RM26-0317 Wairakei South Fast Track Development – Stormwater and Flood Hazard Assessment

Pattle Delamore Partners Limited (PDP) have been appointed by the Bay of Plenty Regional Council (BOPRC) to review the proposed stormwater drainage and flood hazard details related to the Fast Track Application for the Wairakei South Stormwater Drainage project.

Figure 2: Expected Flood Depths in the 1% AEP Flood Event with Kaituna Stopbank Breach

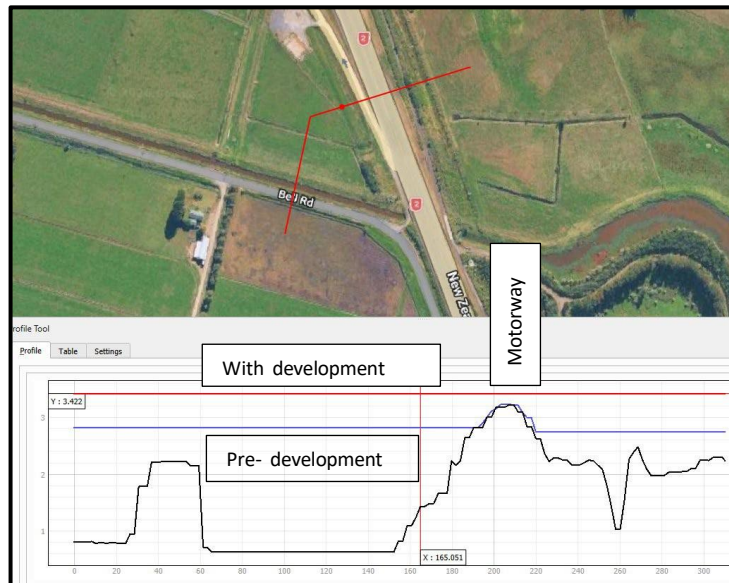
Flood depths are expected to vary from 300 mm to greater than 1,200 mm across most properties. Approximately 200 to 300 mm of flooding is indicated on the Tauranga Eastern Link (TEL). Given the significance of the TEL as a strategic transport corridor and lifeline route, further review of the flood levels, flood durations and associated network resilience impacts is recommended.

Upstream of the development, no change in flood levels is indicated until Parton Road and Te Puke Highway, where significant increases in flood levels, between 50 mm and greater than 100 mm, are observed.

Figure 1: Orthographic view of the model domain, parameter zones and boundary conditions (ENGEO, 2025).

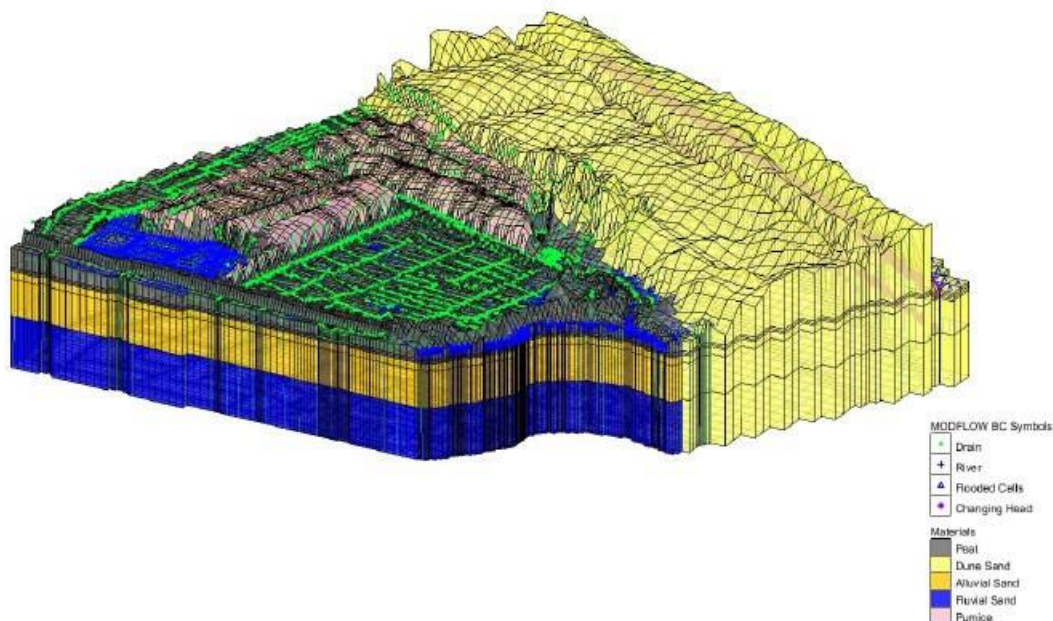
Boundary conditions of the model included the coastline along Papamoa beach, represented as a constant head boundary, a river boundary condition for the Kaituna River and drain boundaries for all other drains, swales and canals in the model domain. No-flow boundaries were used for all other model cells at the domain edges and base. This may limit contributions from horizontal or vertical subsurface flows, however the potential significance of these is not well understood or described.

Figure 2: Modelled post-development drawdown (purple) and mounding (blue) during winter conditions (left) and summer conditions (right), compared to a pre-development baseline (ENGEO, 2025).

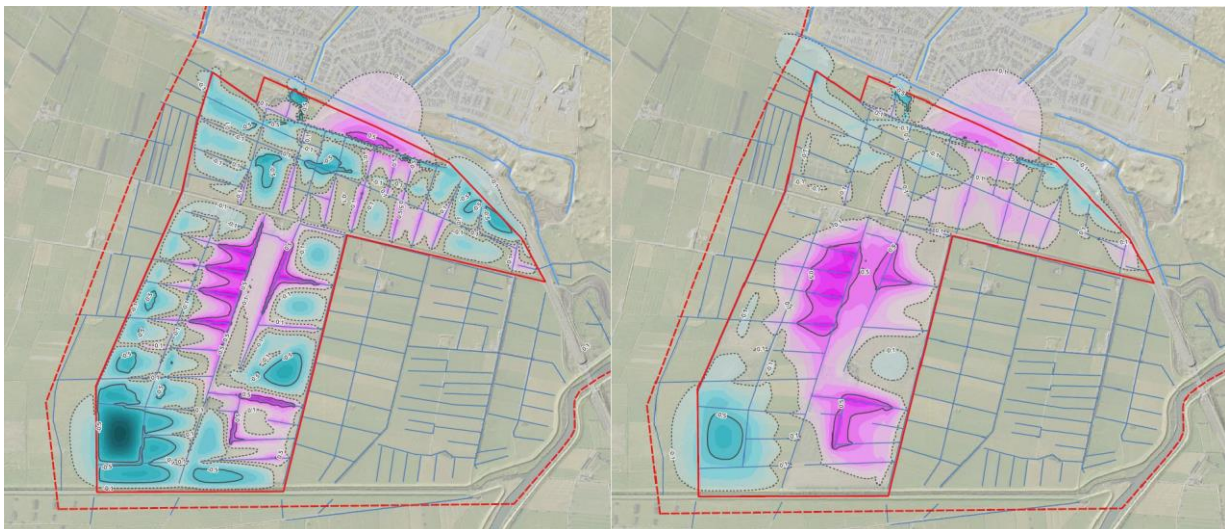
Predicted drawdown and mounding effects associated with the proposal are shown in Figure 2 and illustrate limited groundwater level impacts beyond the site boundaries. We agree that the effects of these groundwater level changes on neighbouring land, the groundwater resource and other groundwater users is considered negligible.
